DEVELOPMENT ASSESSMENT REPORT	
Application No.	DA/2020/0233
Address	16 William Street LEICHHARDT NSW 2040
Proposal	Demolition of the existing building, erection of a three-storey boarding house containing 25 boarding rooms with basement parking and associated works.
Date of Lodgement	06 April 2020
Applicant	William Assets Pty Ltd
Owner	William Assets Pty Ltd
Number of Submissions	Initial: 27 After Renotification: 23
Value of works	\$3,255,356.00
Reason for determination at Planning Panel	Number of submissions exceeds Officer delegations
Main Issues	<ul style="list-style-type: none"> • Impacts to streetscape and desired future character • Amenity impacts in relation to solar access to the surrounding properties • Issues in relation to proposed relation of council stormwater line • Issues in relation to Flood Risk and Stormwater design
Recommendation	Refusal
Attachment A	Reasons for refusal
Attachment B	Plans of proposed development

This report is an assessment of the application submitted to Council for Demolition of the existing building, erection of a three-storey boarding house containing 25 boarding rooms with basement parking and associated works at 16 William Street Leichhard

Figure 4: Street elevations

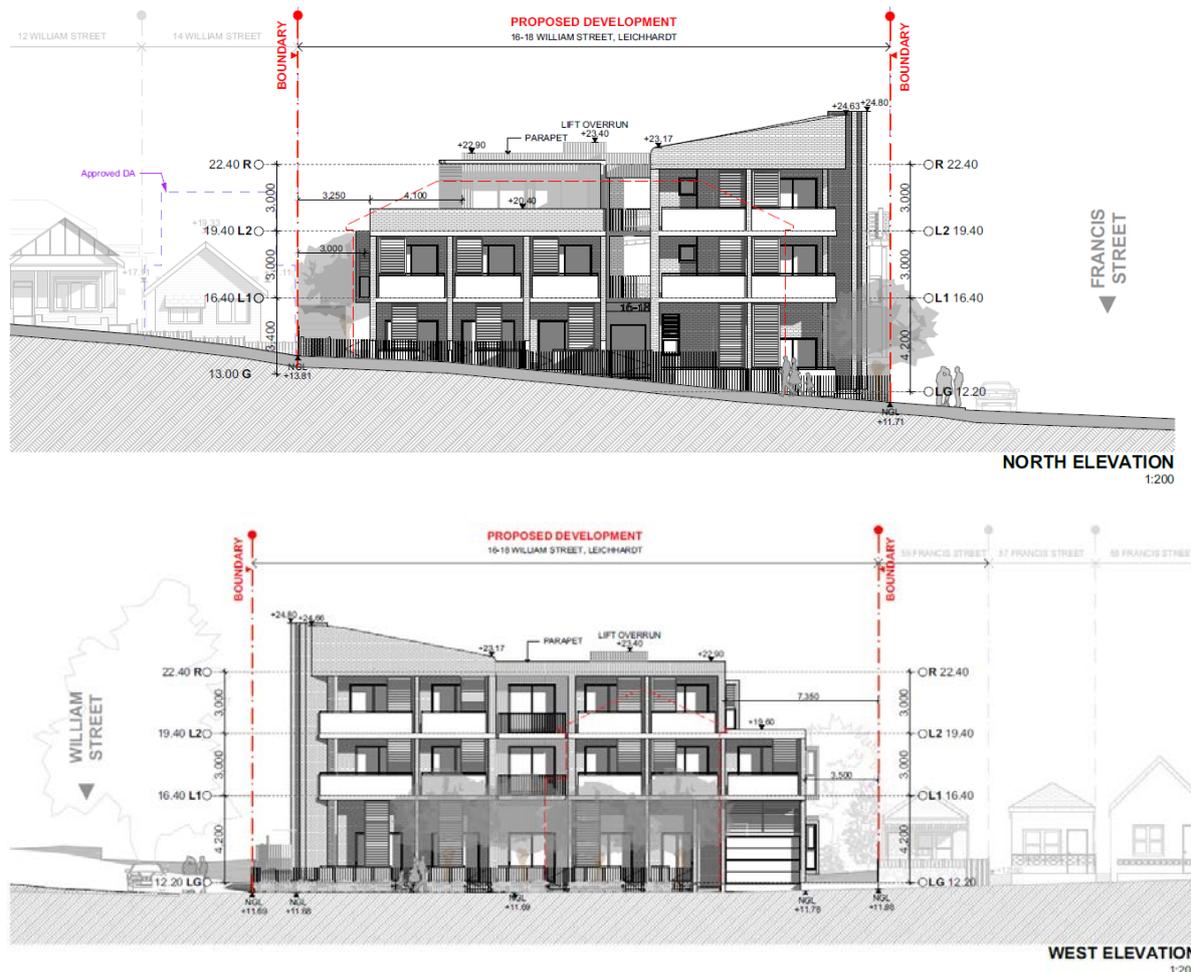
Given the nature of the proposal and the context of the local area, the application was referred to Council’s Architectural Excellence Panel and its recommendations were included in the request for additional information letter dated 1 July 2020. The amended scheme was again referral to the Architectural Excellence Panel and the following comments were provided by the Architectural Excellence Panel:

In summary, while the amended scheme is an improvement to the original proposal, the amended design has not fully addressed the issues raised, in particular, the amended proposal has not satisfied the requirements to provide garage collection/storage room and the common laundry room at ground floor level. The amended scheme also has not provided the required details in relation to external finishes, proposed fencing, a photo-realistic photomontage and wall sections. These details are required to conduct a proper appraisal of the design's contextual fit with the character of the area.

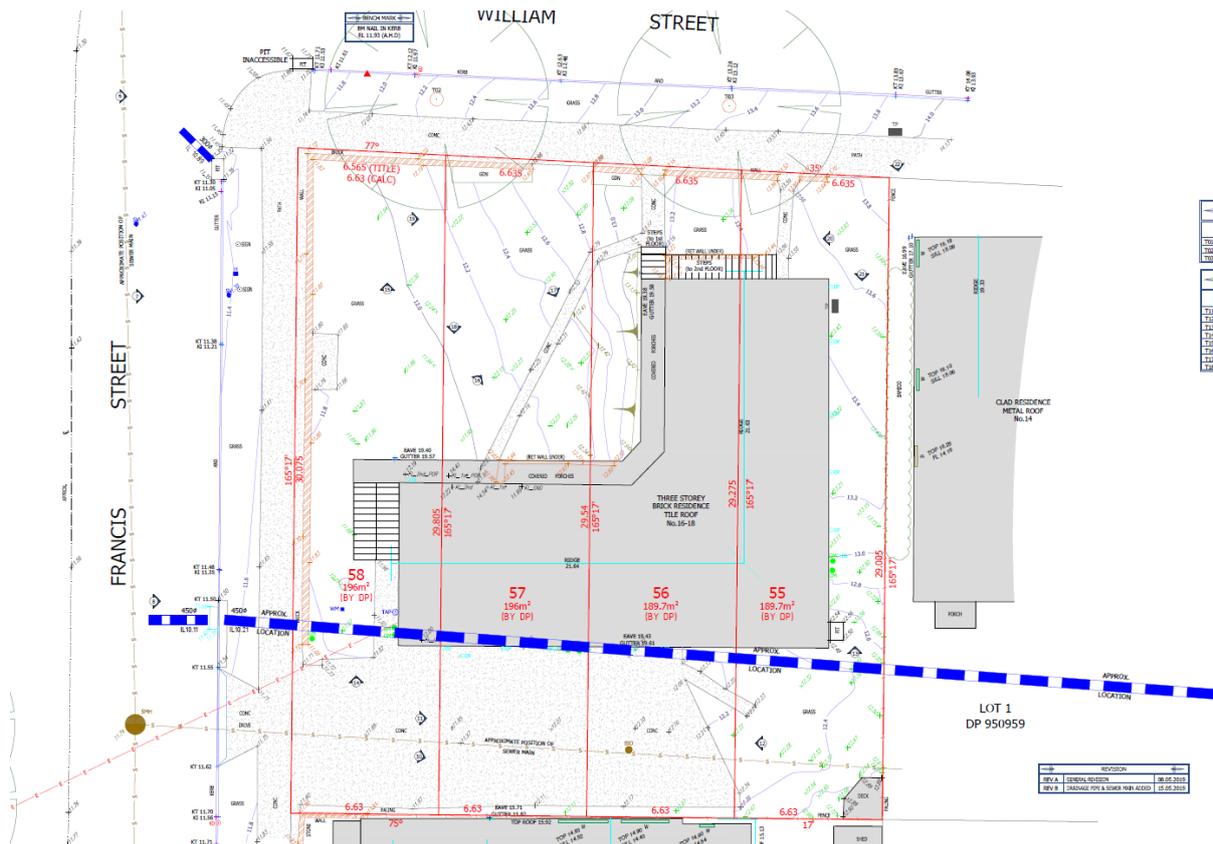
The site is a flood control lot with a Council stormwater pipe and flood flow path that passes through the property – see below.

The proposal is not supported as it does not comply with Section E1.2.6 (Controls C1, C2, C3) and Section E3.1.1 (Controls C1, C3, C9 and C10) of DCP 2013. In this regard, the proposed floor levels and basement entries must be raised to the Flood Planning Level. It is noted that this will require significant redesign as the Flood Planning Level at the north west corner of the William Street frontage is RL 14.45m AHD and the adjacent proposed floor level is RL13.00m AHD and entry to the basement is 13.65m AHD.

Raising the floor levels to resolve flood planning issues will have corresponding effects including exacerbating the overshadowing and privacy impacts noted above.

As the proposed floor levels below the Flood Planning Levels has unacceptable risk to human-life and damage to property, and therefore, will be included as a reason for refusal.

- The proposed floor levels and basement entries must be raised to the Flood Planning Level. It is noted that this will require significant redesign as the Flood Planning Level at the north west corner of the William Street frontage is RL 14.45m AHD and the adjacent proposed floor level is RL13.00m AHD and entry to the basement is 13.65m AHD.
